Re: Urnfield (conditions): Application for approval of details reserved by condition 4 and condition 7 associated with appeal ref. APP/Y3615/W/22/3300200

Tormead Limited
Urnfield Sports Ground

Figure 4.1 Tree protection plan with areas proposed for removal in red

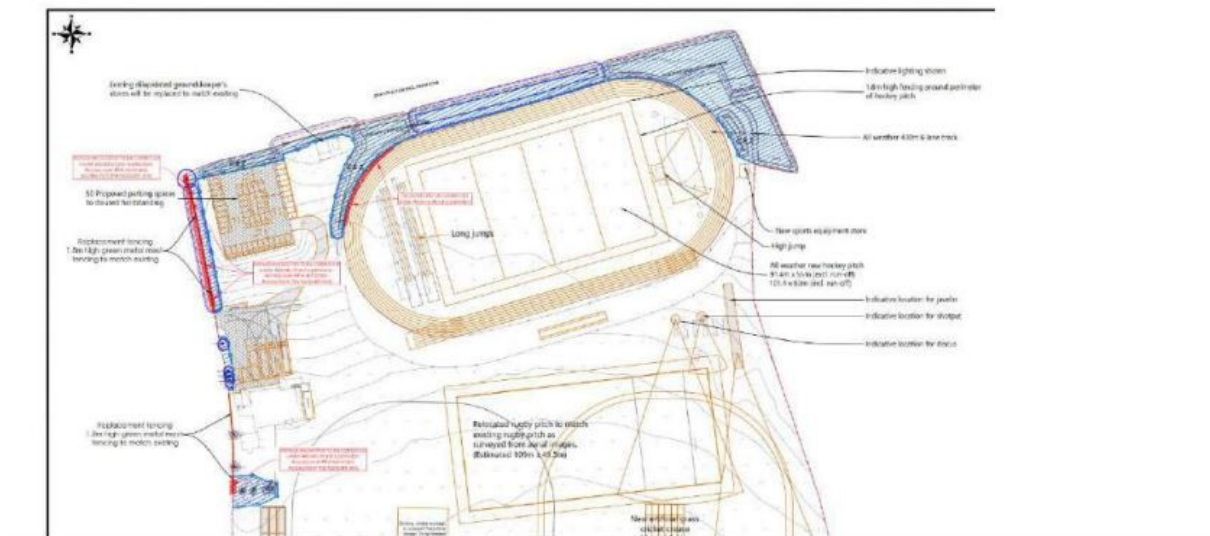
The **Landscape and Ecological Management Plan (LEMP) figure 4.1 (Tree Protection Plan)** shows a "construction exclusion zone" along the northern side of the proposed running track. The areas shown for proposed tree/scrub removal are shown in red. There is only a thin line of plant material proposed to be removed adjacent to the running track along the north western curved edge. The remainder of the tree / hedgeline is within the construction exclusion zone (hatched area on the map, extract below).

Sections of these two approved plans are included below:

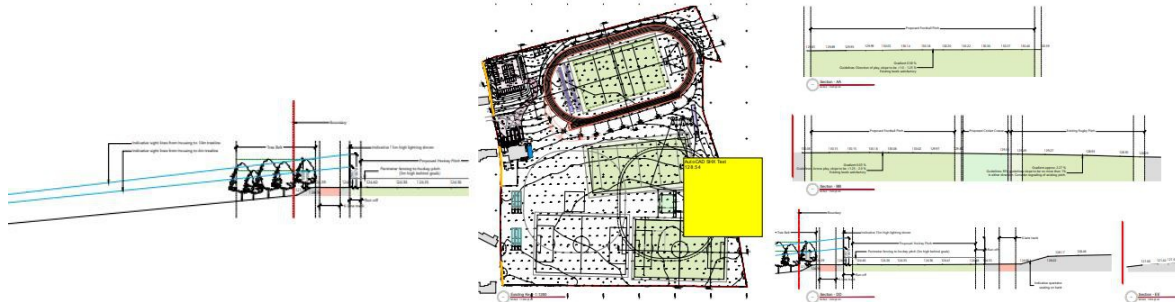
This tree / hedgeline is also shown intact in the drawings 1908-004 Rev B and 1908-007 Rev A, both of which form part of the Planning Inspector's requirements for the permission under condition 2 of her decision:

You will see from 1908-004 Rev B and 1908-007 Rev A (both referenced by the Inspector in condition 2) that the existing tree / hedgeline sits on a steep bank down towards the northern boundary fence.

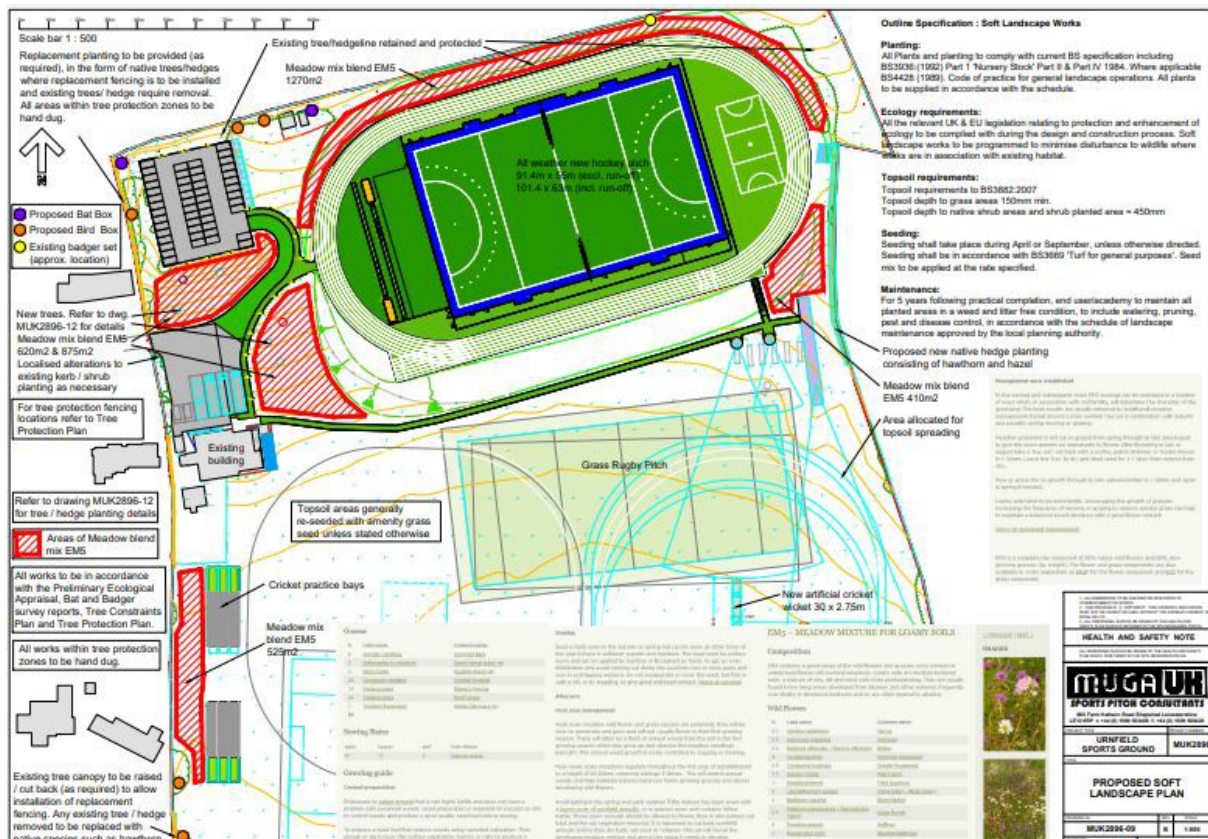
This area of trees and shrubland plays an essential screening function as well as providing important habitat. However, the soft landscaping and planting drawing MUK2896 – 09 submitted against condition 7 suggests a dual use of this area (G6) which is simply not possible – it shows the retention of the existing tree / hedgeline and a simultaneous intention to plant the area with meadow mix blend EM5.

Wildflower seeds on such terrain will simply be washed off in the first rainfall, and a steep northern facing bank (much of which is in shadow for most of the time) will not host a wildflower meadow.

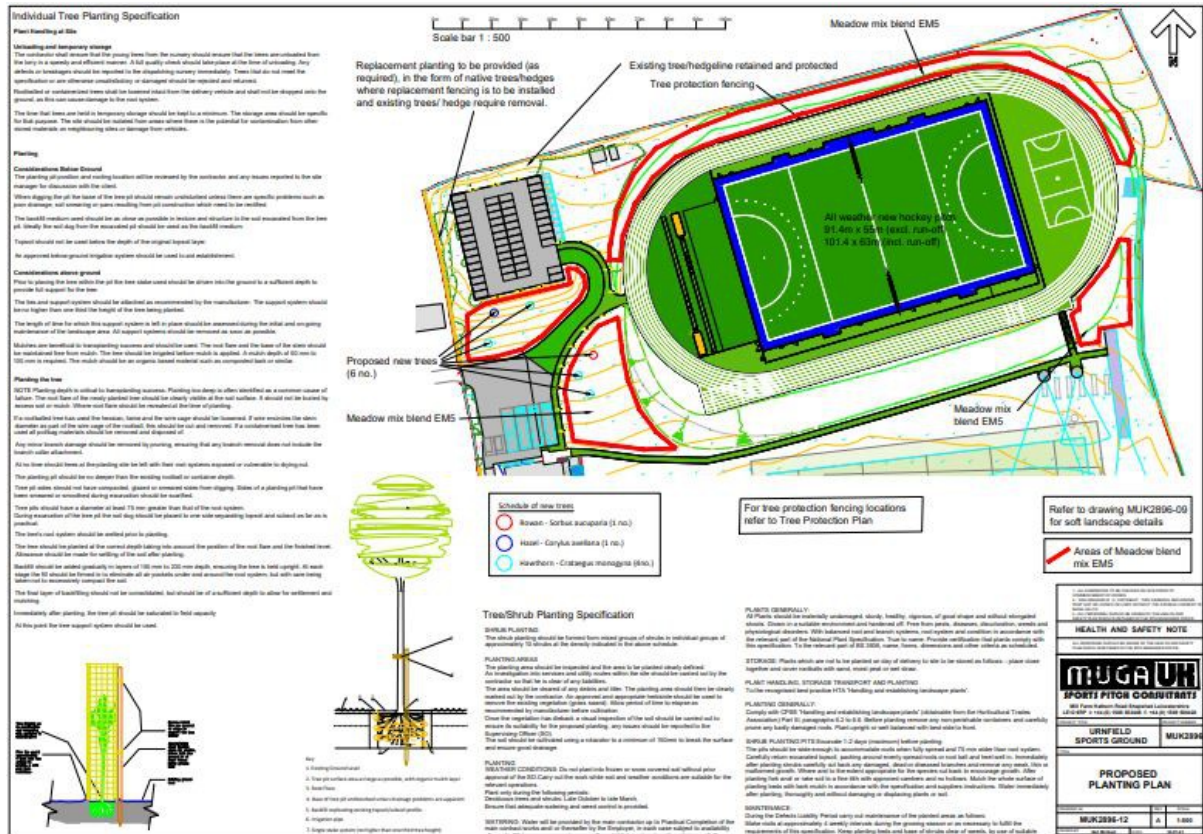
A subsequent drawing, MUK2896-12 removes the tree / hedgeline altogether leaving only the meadow mix blend EM5 in what has been approved (and confirmed in figure 4.1 of the LEMP) as a construction exclusion zone with retention of the existing trees and hedge plants.

These drawings within the soft landscaping and planting plan seem **to introduce a new feature, and to remove what has been approved in condition 2 by the inspector in drawings 1908-004 and 1908-007, and shown in the developer's own LEMP, figure 4.1.**
